Transportation Impact Study Update

PROPOSED MIXED-USE DEVELOPMENT

109 Garden Drive
OAKVILLE, ONTARIO

PREVIOUS SUBMISSION COMMENTS

Figure 19

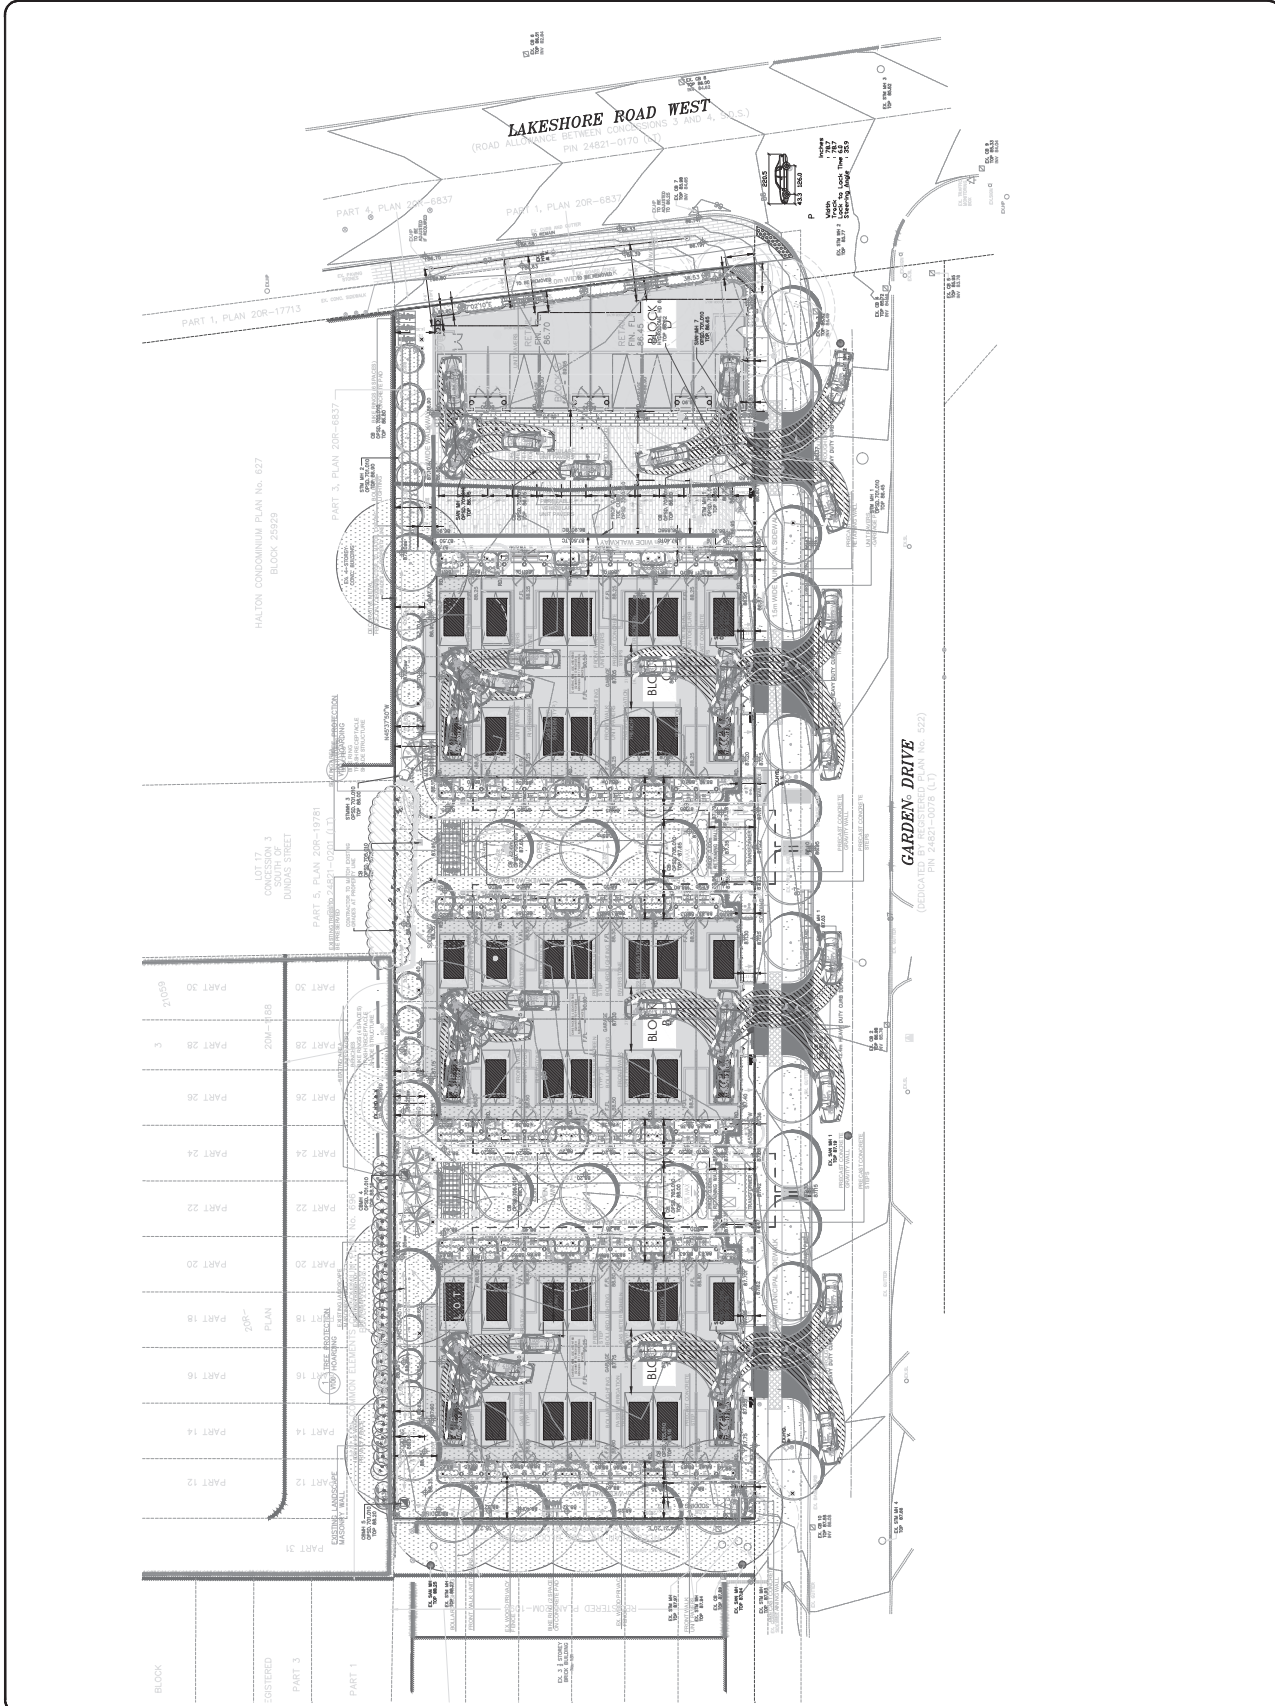
12. **OPA/ZBA Comment** – The design vehicle information is missing from the AutoTURN analysis provided. Please submit a separate site plan with a higher resolution of the turning movement analysis for review and feedback by the staff.

Response: Noted and has been provided in this Study Update.

1 SITE PLAN
SCALE: 1/16"= 1'-0"

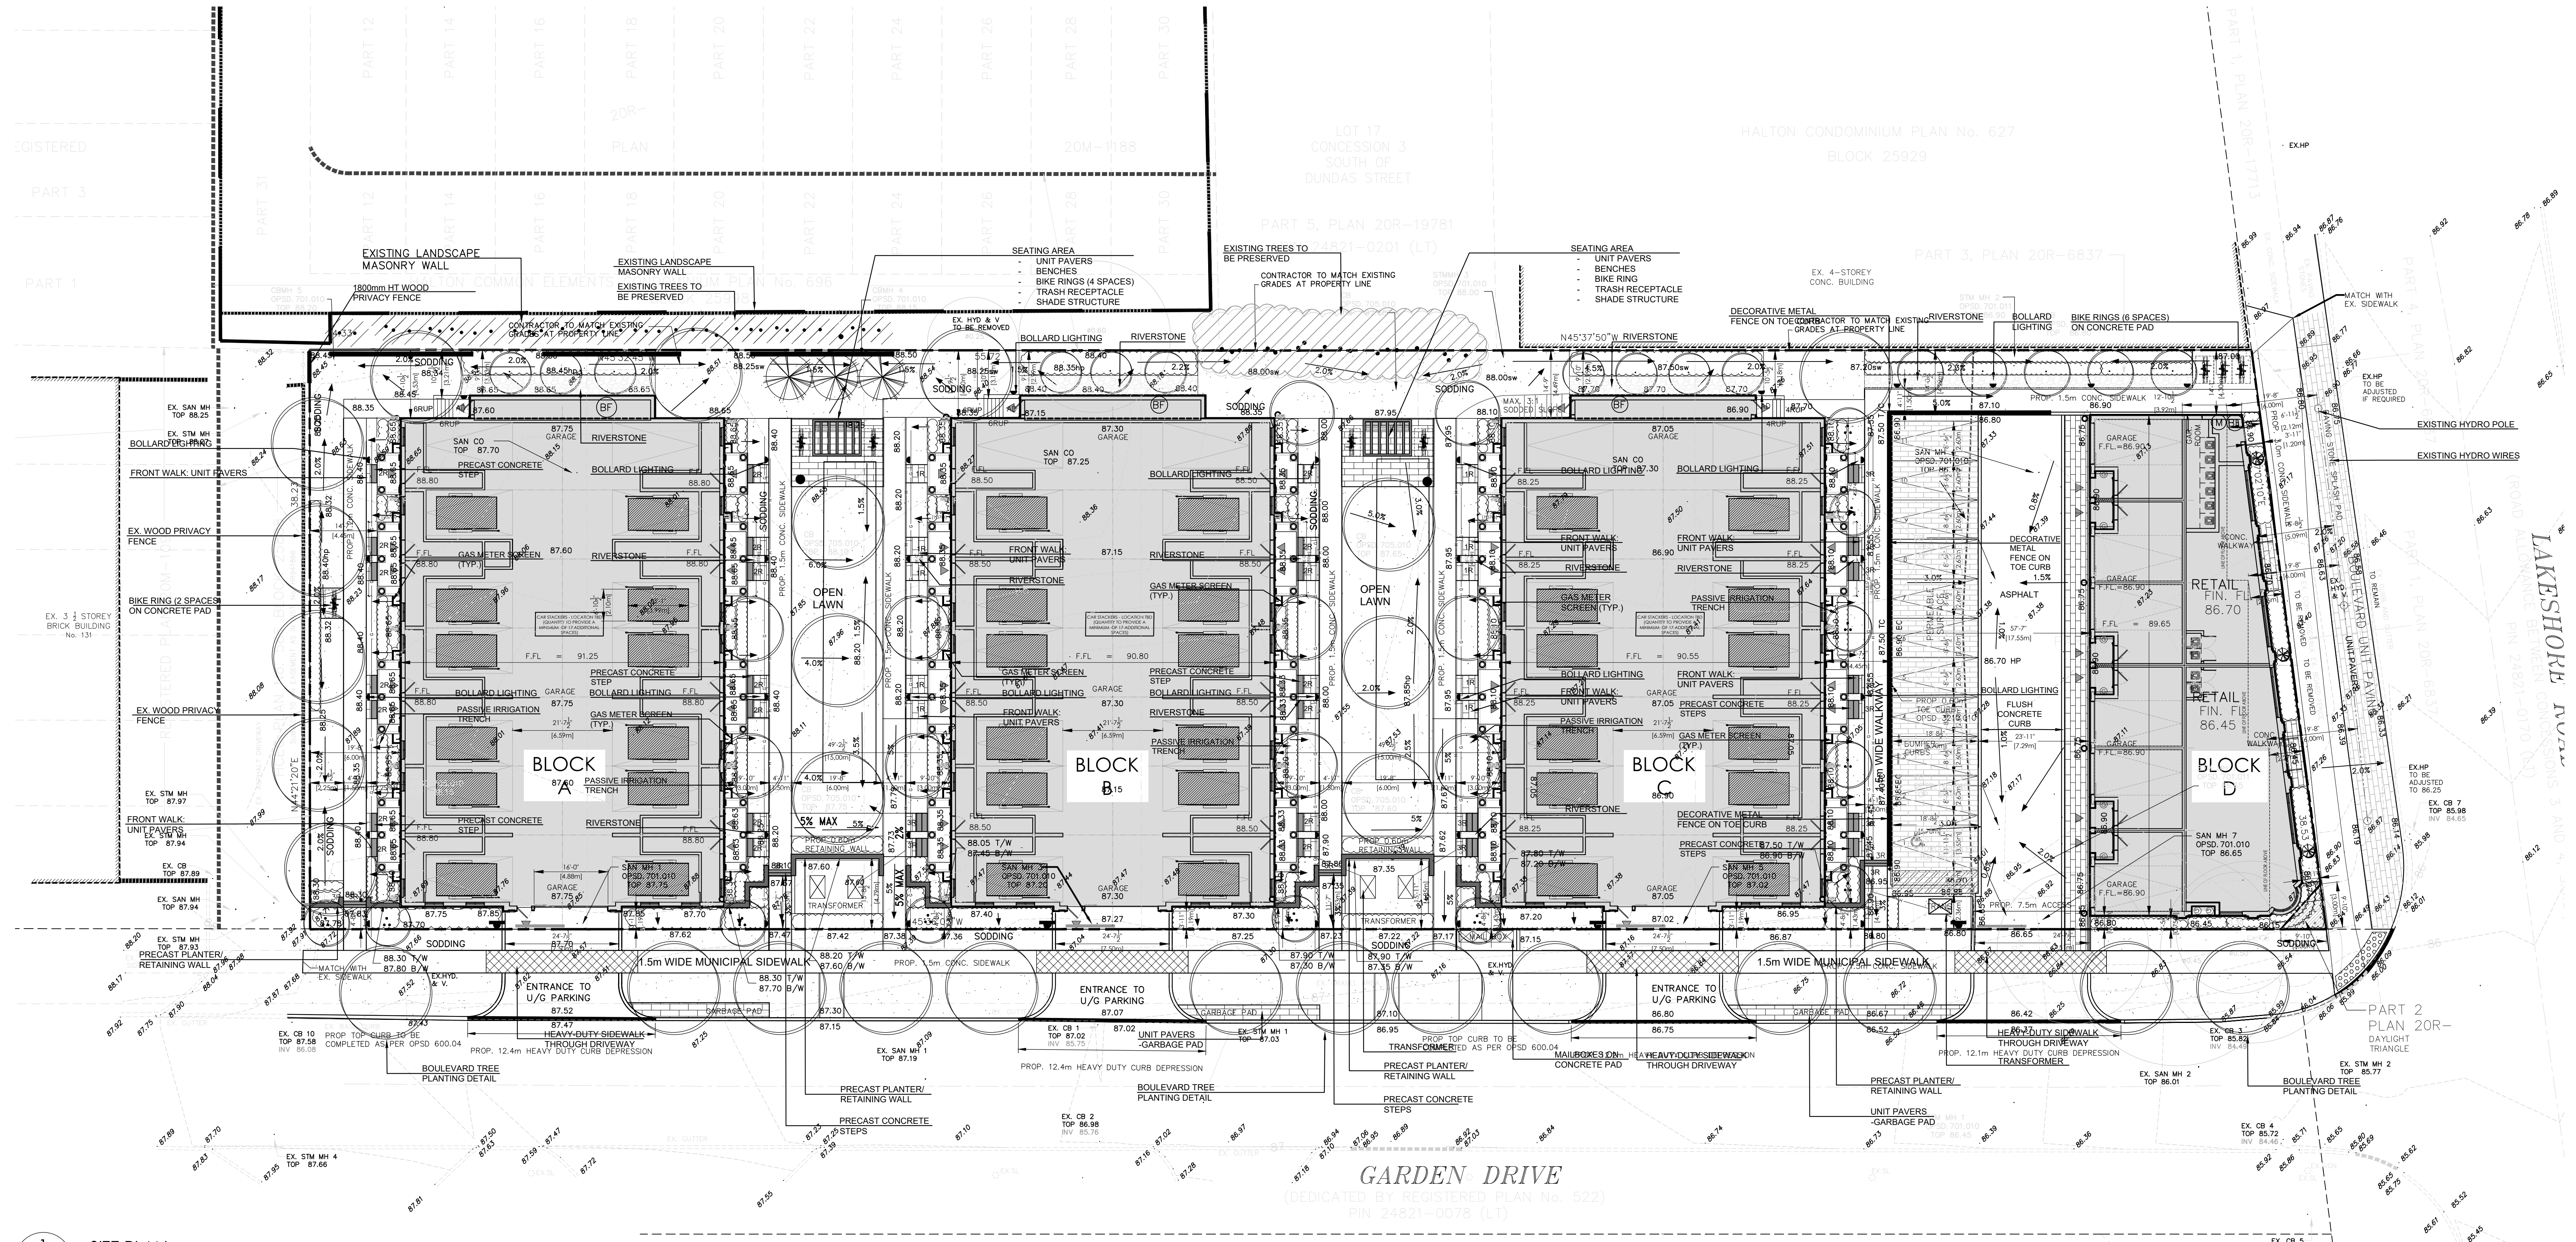
3. **Site Plan Comment** – Site plan showing parking layout plan at all levels must be submitted for review and feedback by the relevant staff.

10. **OPA/ZBA Comment** – The current site plan drawings submitted in the TIS report are illegible, particularly concerning the driveway dimensions at the property line, aisle widths, and parking area specifications. The applicant should provide high-resolution, clearly annotated site plans to facilitate a comprehensive review by Transportation Planning staff.

14. **OPA/ZBA Comment** – The current proposal indicates a shortfall of 16 parking spaces compared to the requirements stipulated in the Town of Oakville's zoning by-law. The justification provided for the reduced parking relies on data from U.S. cities and locations outside Oakville. The applicant is advised to adhere to the parking requirements as per the town's zoning by-law. If a deviation from the by-law is sought, a comprehensive parking justification study, based on approved Terms of Reference (TOR), should be conducted and submitted for review for the Transportation staff. The selection of proxy sites for this study must be pre-approved before conducting the parking surveys.

Response: Noted. The site plan showing parking layout plan is provided in **Appendix A** of this Study Update.

Response: Noted and has been provided in **Appendix A** of this Study Update.

Response: The proposed development now meets the Zoning By-law requirements by providing an additional 17 vehicle parking stackers for certain units. The Zoning By-law requirements for vehicle parking has been updated in this Study Update. The proposed development provides a total of 76 vehicle parking spaces, including 65 resident spaces and 11 visitor spaces, which generally meets the overall Zoning By-law requirements.
